Re: ZC # 11-03, Southwest Waterfront 1st Stage PUD

CASE NO. 11-03
EXHIBIT NO. 104

**ANC 6D Resolution in Support of Hoffman Madison-Marquette
Southwest Waterfront First Stage PUD Case No. 11-03**

Exhibit A – 6th Street Section – looking SW

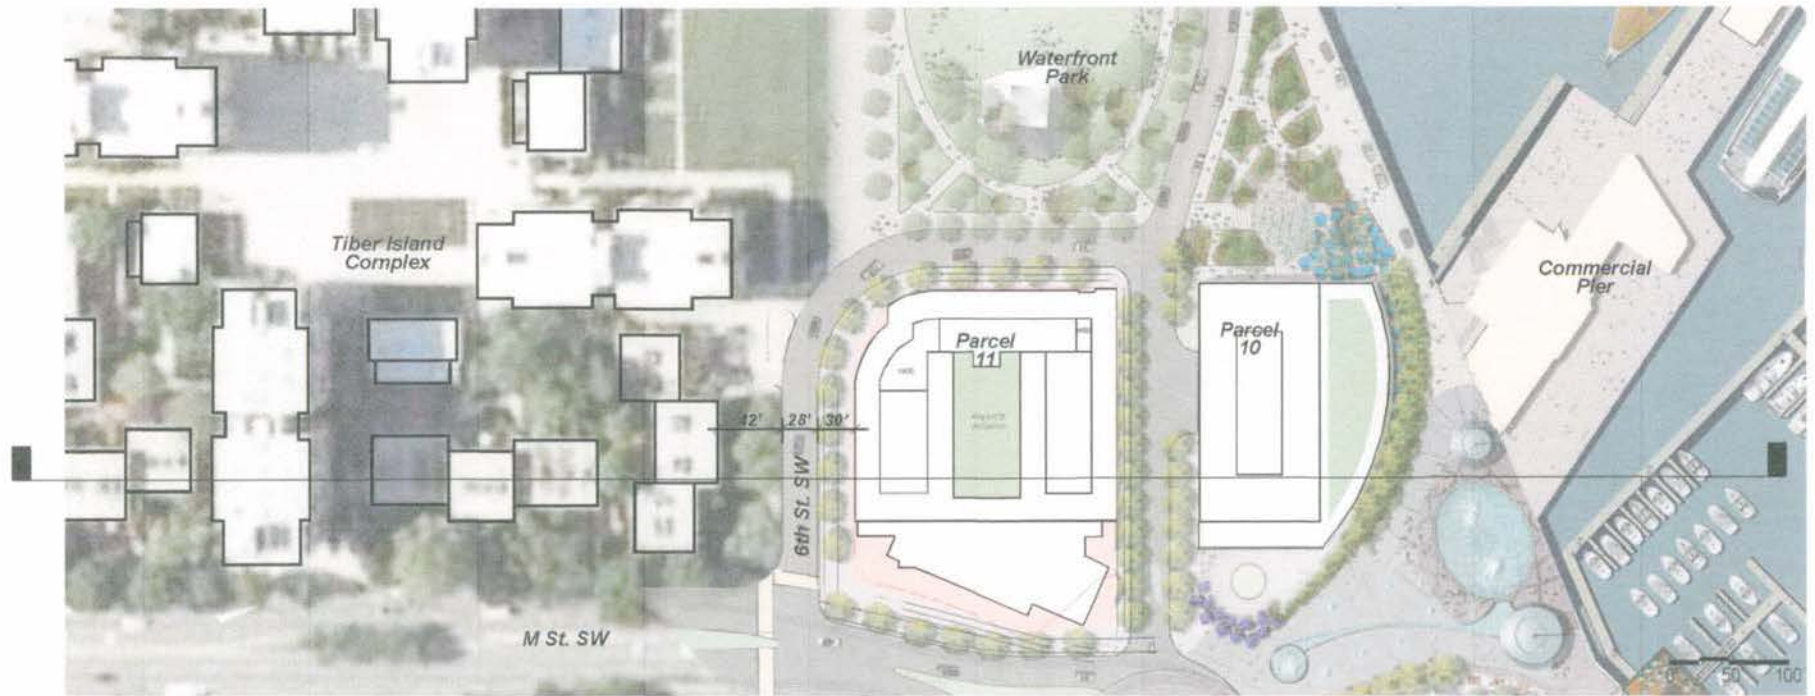
10. Parcel 11 - The redevelopment of Parcel 11 into a dense residential development is a concern. While ANC 6D is prepared to accept this change, the resultant development must not be inconsistent with the existing residential fabric. Preservation of the height limitations within the R-3 district is necessary to ensure Parcel 11 is sensitively integrated within the existing successful, well-knit fabric of low-rise townhouses that defer to the public space by exhibiting generous setbacks. In particular, setbacks on residential (South) side of M Street from Sixth Street to Second Street, SW share generous setbacks that the design on Parcel 11 does not appear to embrace. Further, the lack of setbacks within the design on Maine Avenue provides a stark counterpoint to the significant lush setbacks provided by the lawns on the Maine Avenue side of The Meade Center. ~~{strikethrough ANC addition to motion of 8-22-11}~~. **Note new ANC6D motion and accompanying illustration attached to this document as Exhibit E.**

HMW response 7-15-11: HMW recognizes the concern and has recently improved its plans to demonstrate that the proposed use and structure is compatible with the existing neighborhood. It should also be understood that the height limitations for a church in existing R-3 is sixty feet, and for other structures it is 40 feet. The effective height of the existing residential along 6th Street SW, the area of most impact, is +/- 40' with the grade change which makes the proposed residential development compatible with the existing Tiber 4 story townhomes and not significantly different than the existing zoning height requirements. The existing setback at Tiber Island from the curbline is approximately 22' to the garden wall and approximately another 20' to the building face of the four story townhomes for a total of 42'. The proposed development will allow a 12' setback from the curbline to the landscape fence (3' tall) and a total of approximately 30' to the building face of the proposed residential structure. The building separation between the face of closest Tiber townhomes and the face of the new residential building will be approximately 100'. The section along 6th Street SW looking south will be similar on the Tiber / HMW sides of the street making the development compatible with the existing fabric. (See Exhibit A). The proposed Church setback along Maine Avenue/M Street is similar to all existing structures along the south side of the street and will not significantly inhibit views along the view corridor and out to the water (See Exhibit B).

Exhibit B – Plan Section of Parcel 10/11

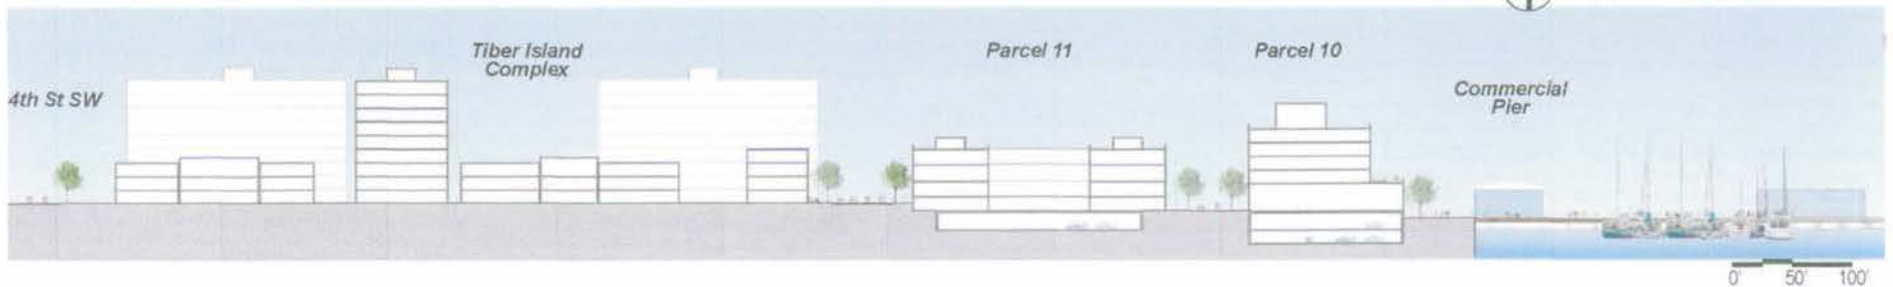
11. M Street Landing – ANC 6D believes that Parcel 9 and 10 need to be brought down to 90 and 45 feet high, respectively, and that Parcel 11 be set back within the M Street corridor. This crucial area anchoring the waterfront development needs to more successfully exhibit sensitivity to the existing residential neighborhood. As proposed, these buildings create a jarring transition. ANC 6D needs to be assured that the height of the buildings on Parcel 11 will be no higher than 45 feet so that it fits within its waterside and low-rise residential context. The height of Parcel 9 should be tapered so that it's in line with buildings on the opposing side of the Landing and provides a transition to the taller buildings to the north. Most importantly, topping out Parcel 9 at 90 feet would ensure it doesn't diminish the landmark Meade Center for American Theater. **ANC motion 7-11-11**

HMW response 7-15-11: The proposed Church setback along Maine Avenue/M Street is similar to all existing structures along the south side of the street and will not significantly inhibit views along the view corridor and out to the water (See Exhibit B). The height of Parcel 11 will be no higher than 45' for the residential and 49' for the church as indicated in the Updated PUD Submission Page 5.7. Parcel 9 and 10 have been carefully shaped and positioned in close coordination with the Arena stage and their architect Bing Thom. Arena Stage is our closest and most impacted neighbor (Tiber Island residences are approx. 550 feet away). The primary concern was not building heights but setbacks to allow for a grand Maine Avenue terminus at M Street landing and a framed view of the theater looking back. The setbacks were achieved by diminishing the building floor plate

Exhibit E – Site Plan for St. Augustine’s Church showing 21’11” set back from Maine Avenue SE curb to front fascia of church.

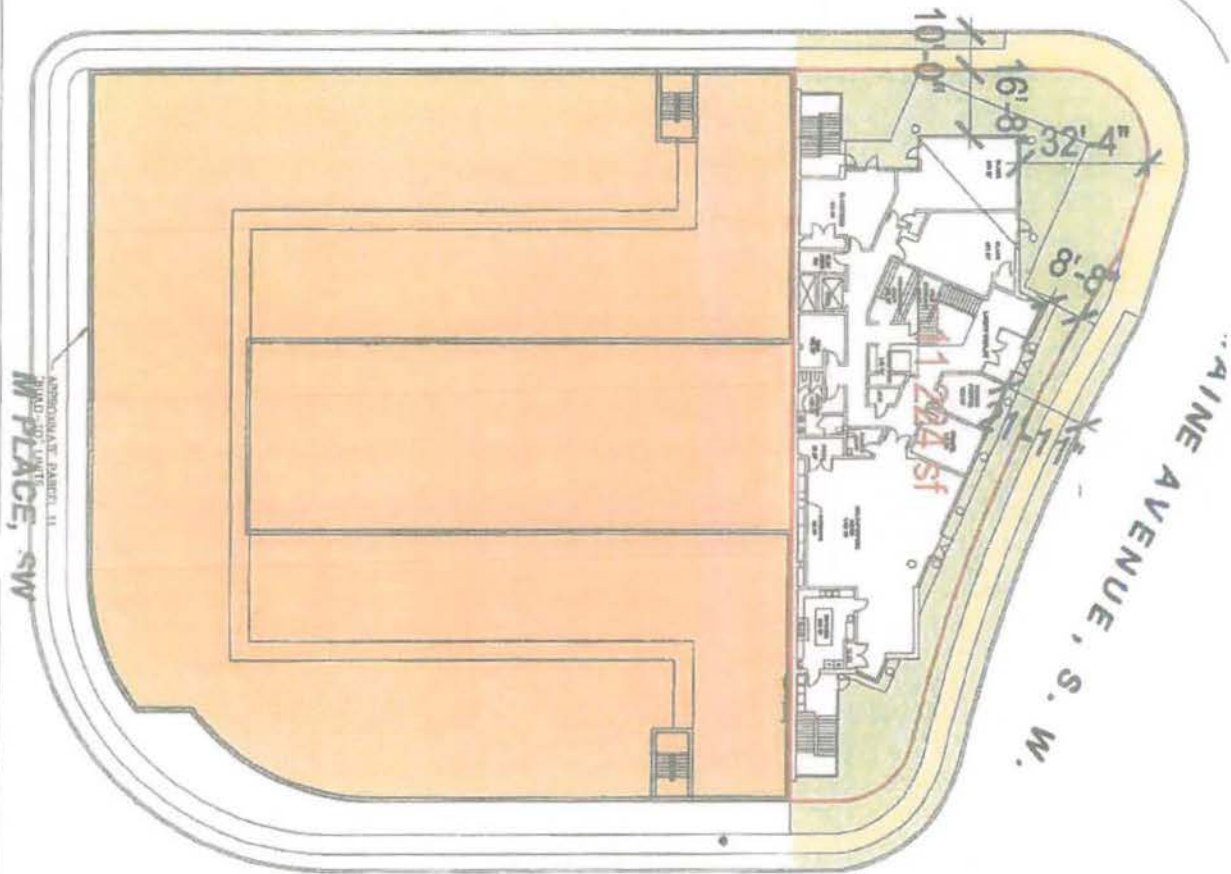
{The redevelopment of Parcel 11 into a dense residential development remains a concern. We ask that the Zoning Commission ensure that the resulting development be consistent with the existing residential fabric and be particularly sensitive to the well-knit fabric of low-rise townhouses at Tiber Island that defer to public space by exhibiting generous setbacks. ANC6D wishes to ensure that the overall height limitations (including all architectural elements, mechanicals and/or equipment) on the residential units be constructed no taller than the Tiber Island residential townhouses located directly across Sixth Street, S.W., that all parking, and infrastructure support (including trash pick-up, deliveries, etc.) are incorporated internally within the design and not exposed to view. Further, ANC6D urges the Zoning Commission to assure that the design of the new St. Augustine's Episcopal Church is set back sufficiently on the site and not diminish the experience of arrival at the Waterfront traveling west along M Street, S.W. **ANC addition to motion of 8-22-11** }
